Council Meeting - Agenda Item 9.5 - Attachment 4
Representations - 54A Mulgrave Street South Launceston - 23 September 2021

DA No: DA0401/2021

RE: DA0401/2021 54A MULGRAVE STREET SOUTH LAUNCESTON

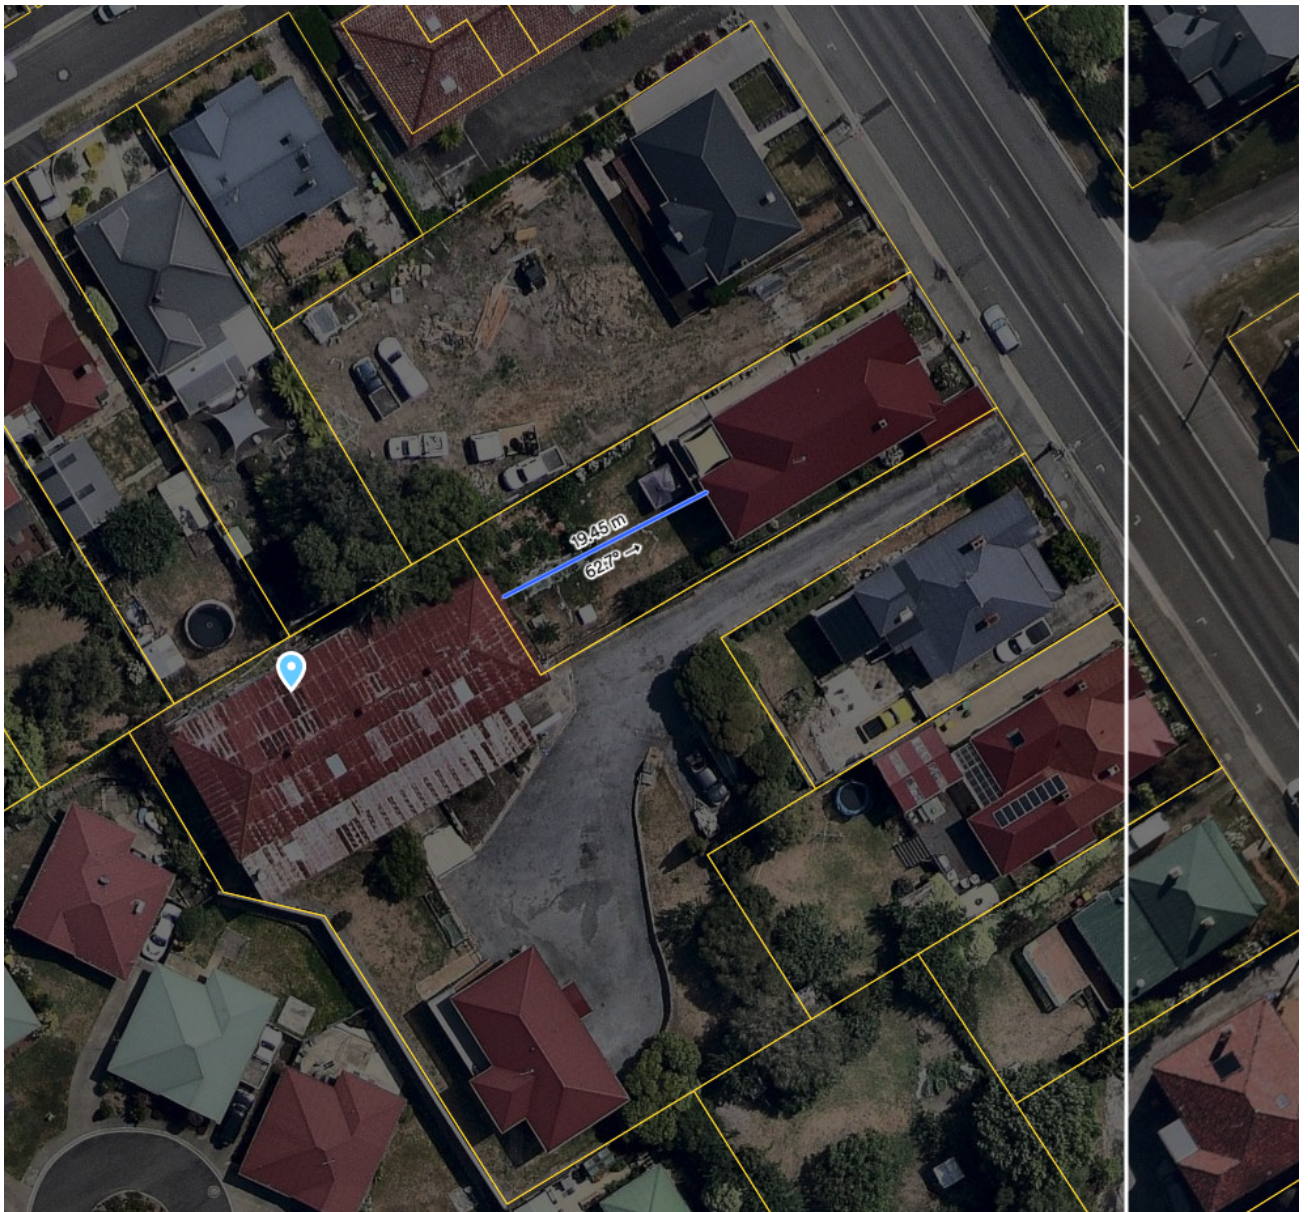
Clause 10.4.2 (Setbacks and building envelopes for all dwellings), Standard A3, requires an internal block to have a setback of 4.5 metres. The proposal does not meet this standard and will be assessed against the performance criteria (P3). The proposal does not meet the requirements of Standard P3 as follows:

- No overshadowing diagram has been submitted and the extent of overshadowing cannot be determined

- The only area of secluded private open space to our property at 54 Mulgrave Street will be overshadowed, reducing basic amenity and usability of the open space.
- The proposed height of the development will present unreasonable visual impact. The scale and bulk of the proposal has no consideration for the character of the surrounding streetscape and low scale design of adjoining properties.
- The separation between [REDACTED] and the proposed dwelling is inconsistent with adjoining dwellings. We draw attention to the nearby adjoining property at 56 and 56A which features an internal setback of approximately 18 metres from the front dwelling. (pictured below).

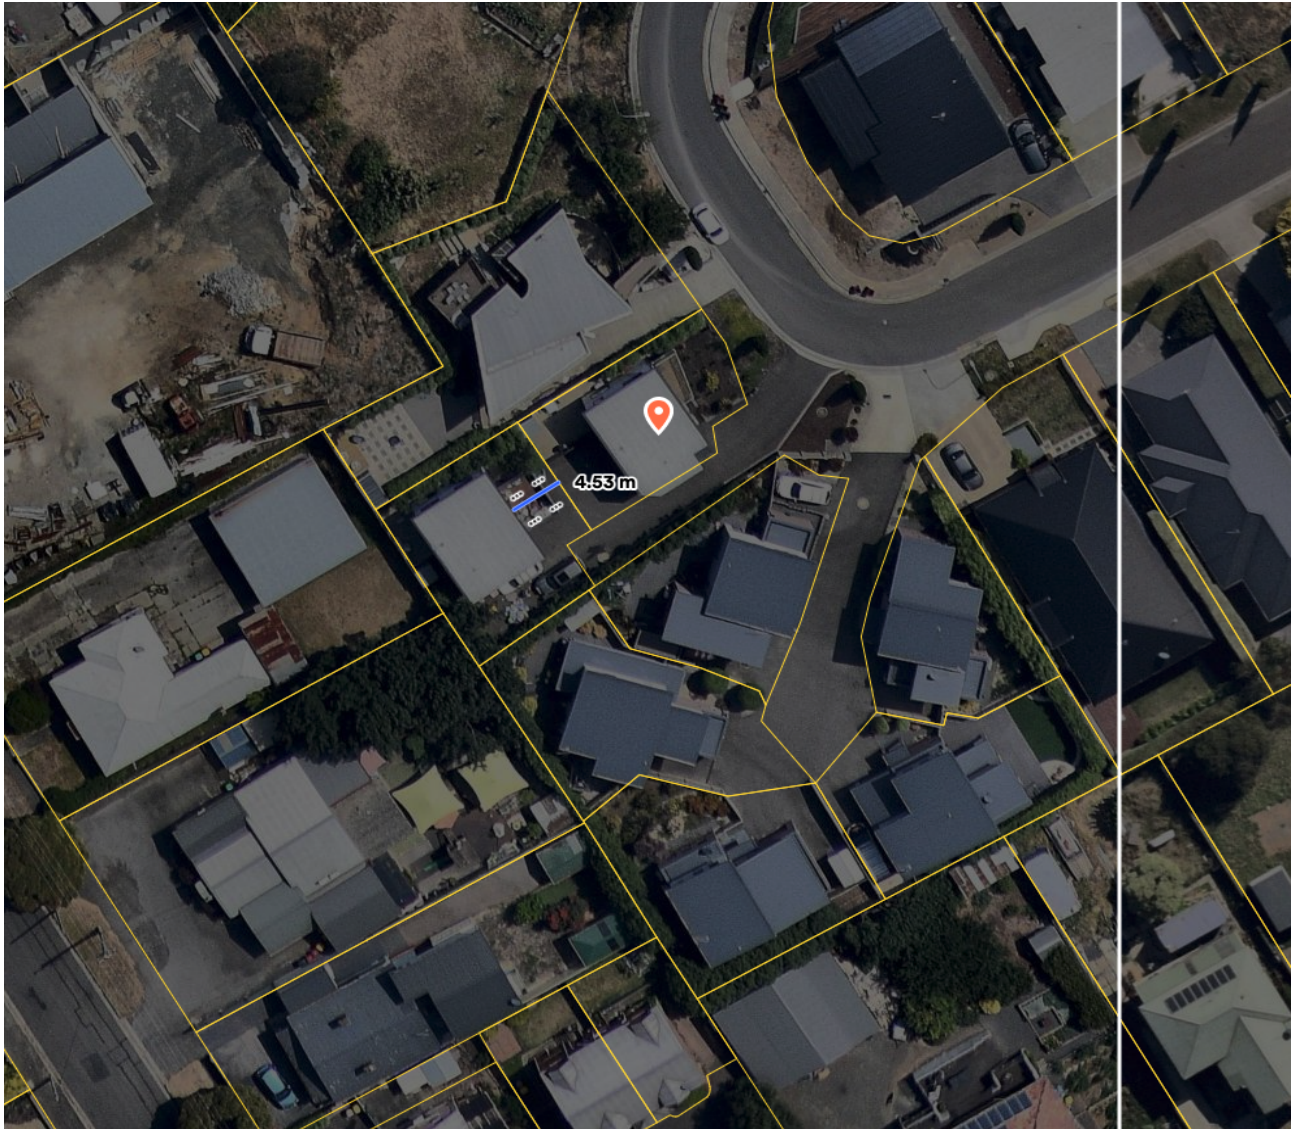
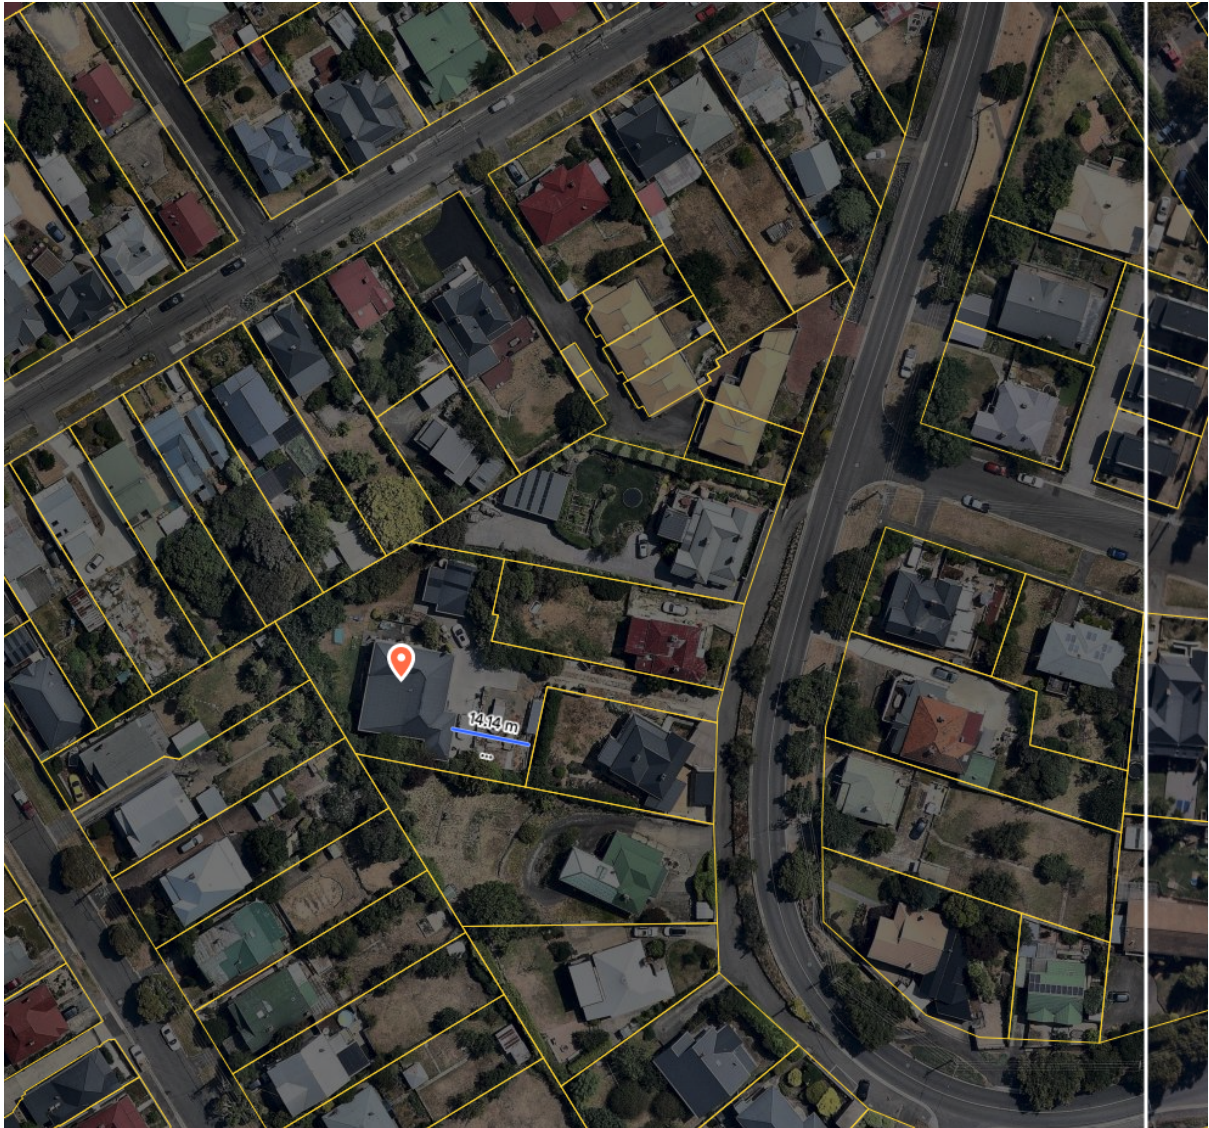
- Other examples in the surrounding area include 6 Karla Place, which includes an internal setback of a minimum of 4.5 metres and 12 Meredith Crescent featuring 14 metres (pictured below).
